DEVELOPMENT REVIEW COMMITTEE

2. Santaquin Research & Tech (Summit Data) Center Commercial Light Manufacturing Site Plan

CORTLAND TOWNHOMES

SUMMIT DATA CENTER
SOUTH RIDGE FARMS ROAD, SANTAQUIN UT, 84655
COVER SHEET

SHEET NO. C1.0

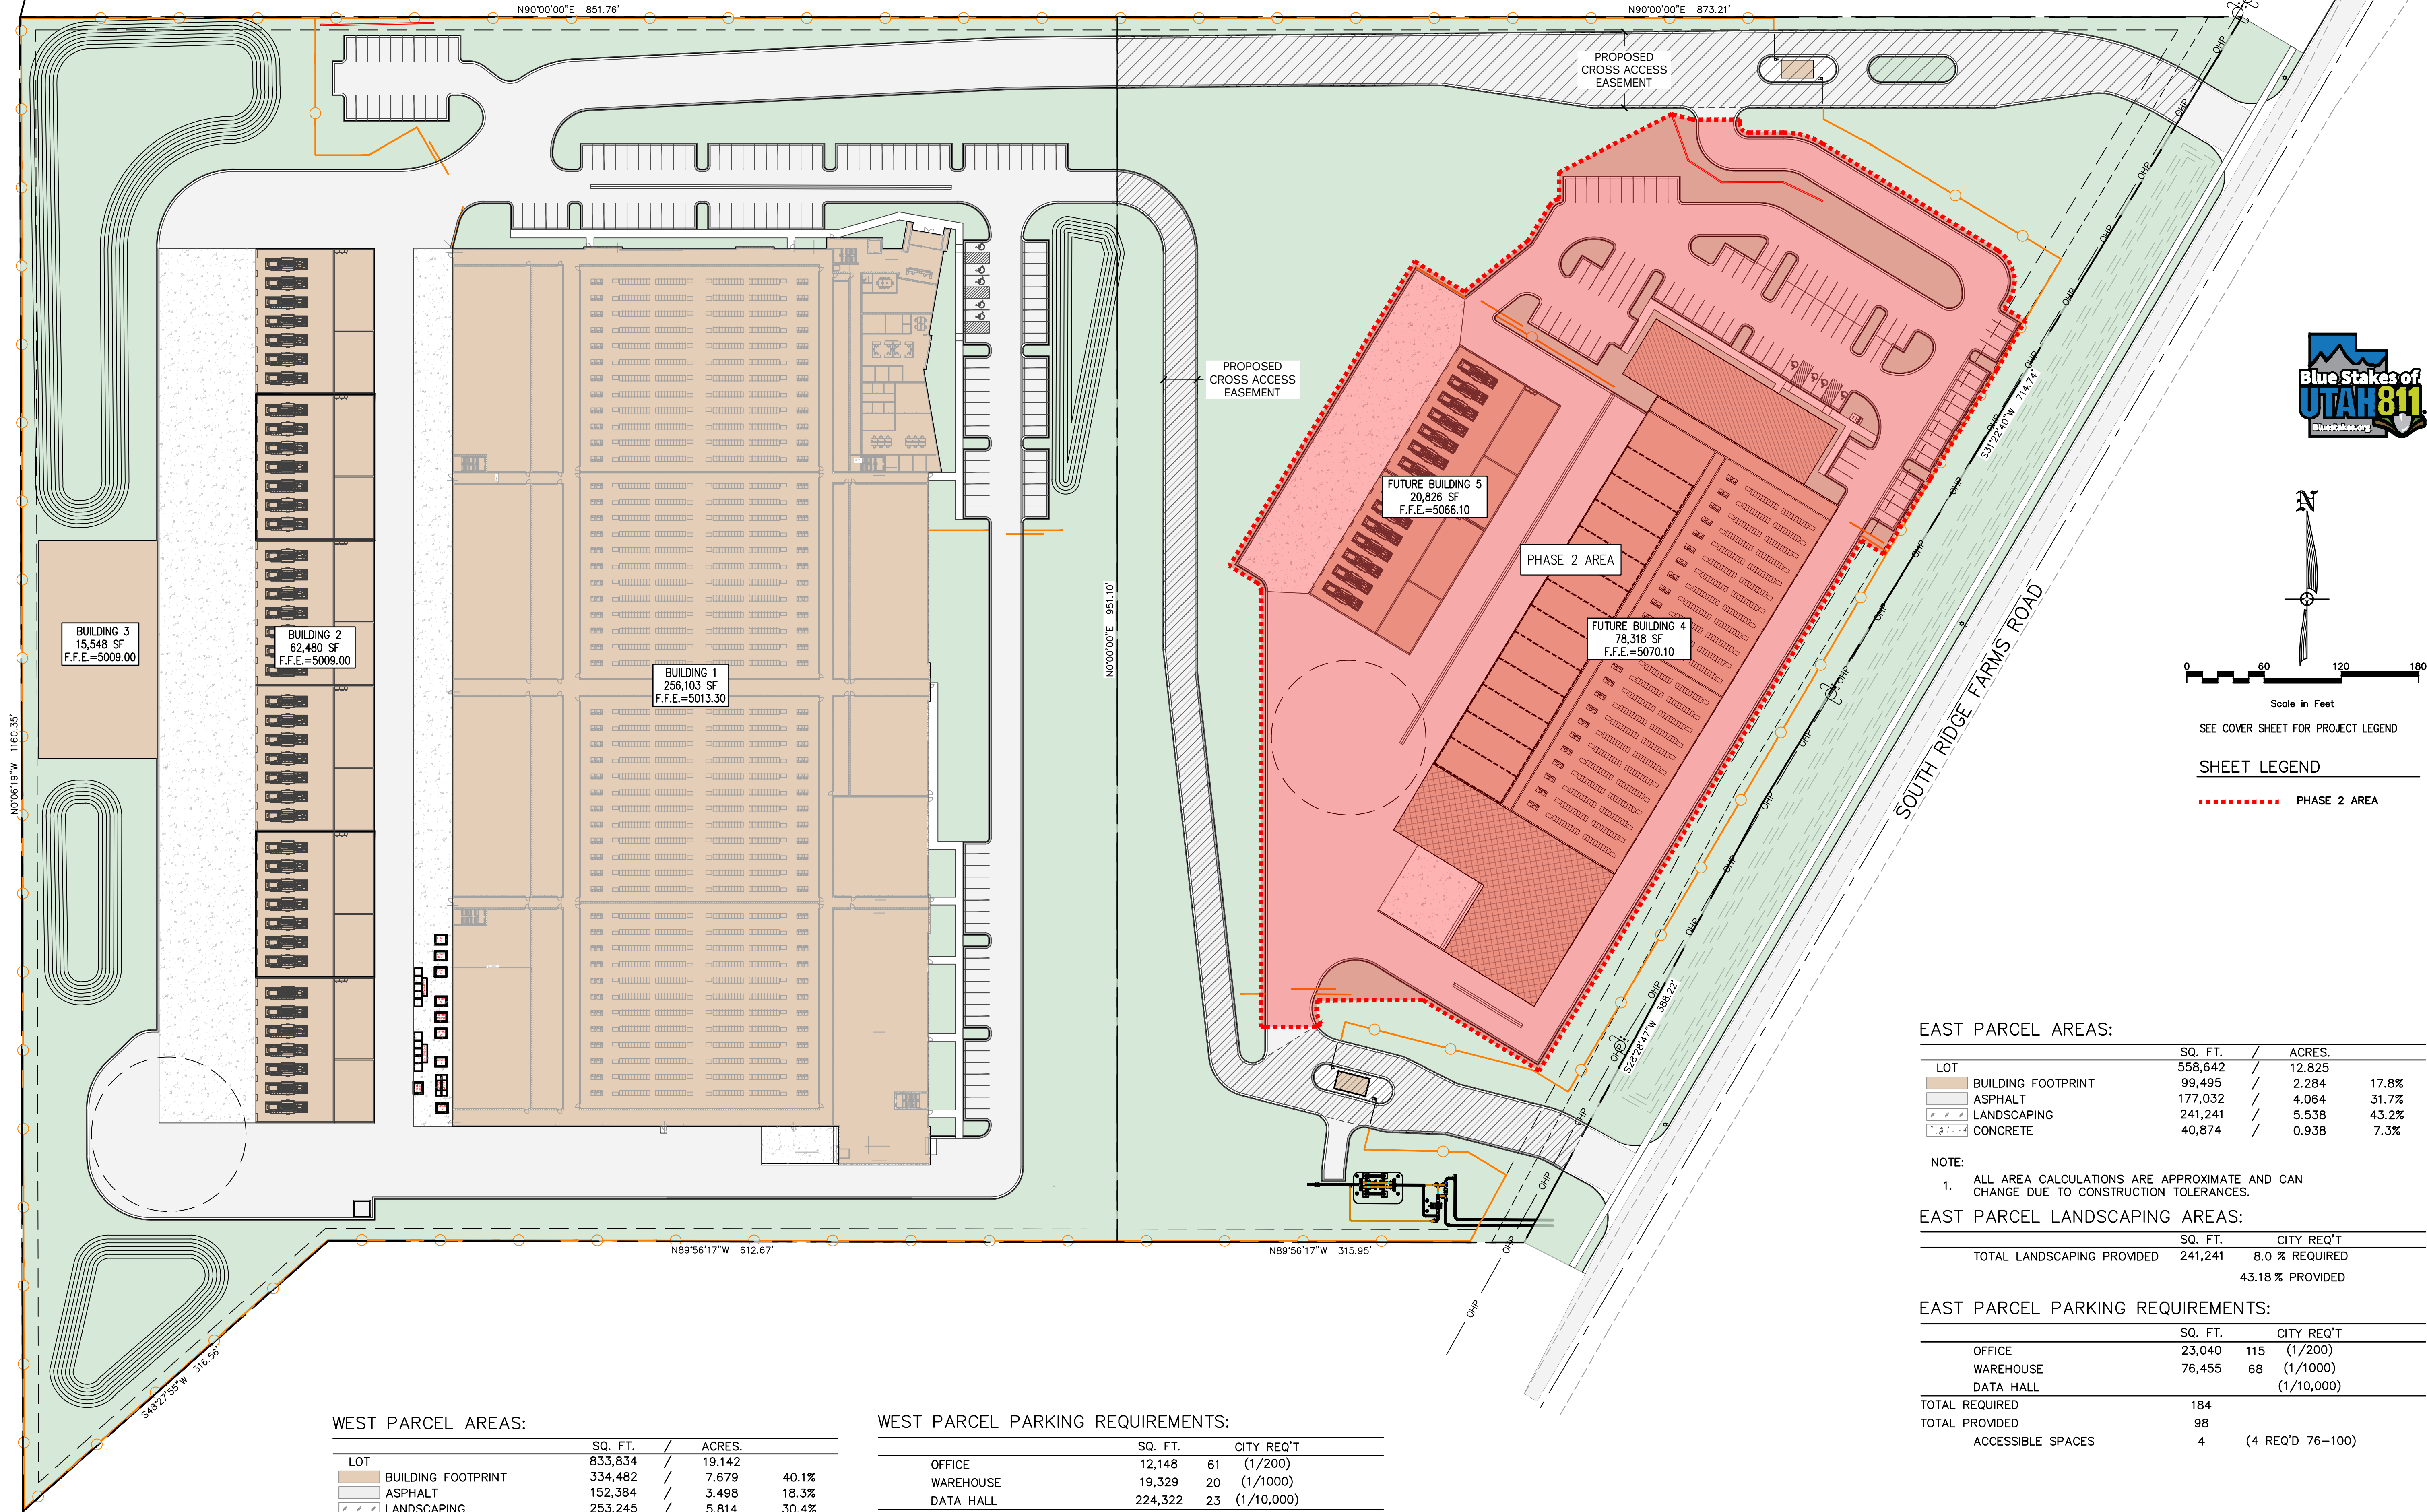
- 1) Type of Construction will determine the required fire flow. Please provide this information

- 2) Please list the type of Fire Suppression system planned to be used. This will help determine the needed flow for the suppression system. The use of the Victaulic Vortex System is advised due to the nature of contents, as well as the reduced water needs.

- 6) Need to provide water line looping to all hydrants. This project will require a second water line to the property to provide looping to ensure the system is not only fed by one line

- 7) Need to add additional FH's and reduce the spacing. Some are greater than 700' apart. No more than 400' spacing is allowed by fire code.

Type IIB Construction. Based on the type of construction and the largest building size of 256,000 square feet, per IFC Table B105.1(2) the required fire flow would be 8,000 GPM. Because the building is fire sprinkled, per Table B105.2 a 75% reduction can be applied, which would result in a required fire flow of 2,000 GPM. We would like to verify that the 2,000 GPM is the design flow we'll need to meet.

Understood. A second connection off the 10" main in the road (South Ridge Farms Road) has been added to the plans at the south end of the site and connected to both building loops. All hydrants are now on a looped system. It is also understood that a second, parallel, water main may be required from the 12" main in Summitt Ridge Parkway, running parallel to the 10" main in South Ridge Farms Road, to the site for a second water line connection to the site. We will be doing a fire hydrant flow test to evaluate flows and pressures to determine the second water line size and resulting fire flow being provided.

Plans have been updated to provide hydrant spacing that does not exceed 400'.
